Modification of Development Consent

For the following: Wollar Solar Farm

Modification: **SSD-9245-Mod-3:** Modification to facilitate an increase in AV/B-double vehicle movements and over-dimensional vehicle movements.

Site Access

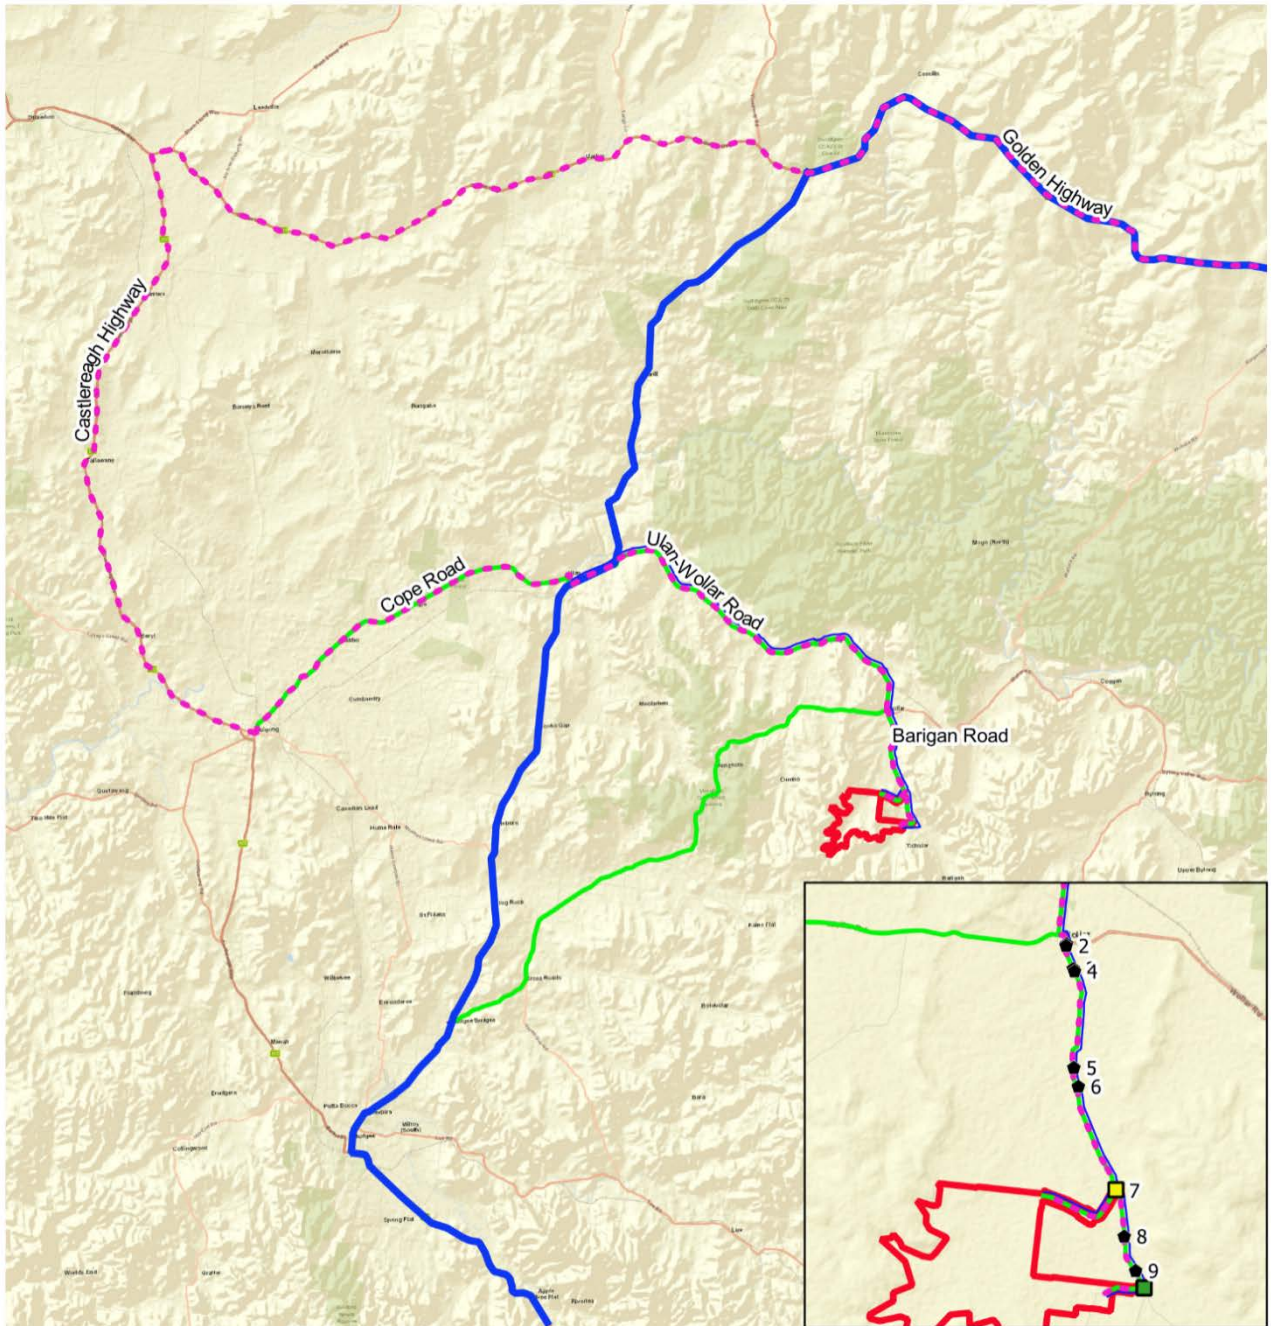
3A. The two over-dimensional vehicles associated with the transport of the transformers must travel to and from the site via Golden Highway, Castlereagh highway, Old Mill Road, Rouse Street, Station Street, Cope Road, Robinson Street, Mackay Street, Main Street, Ulan Road, Ulan-Wollar Road, Barigan Street, Maitland Street, Wollar Road and Barigan Road as identified in the figure in Appendix 3;
8. In condition 9(a) of Schedule 4, replace '2018' with '2020'.
9. In condition 10(b) of Schedule 4, after 'date', insert the following: 'to the satisfaction of the Planning Secretary'.
10. In Appendix 3 replace the figure with the following figure:
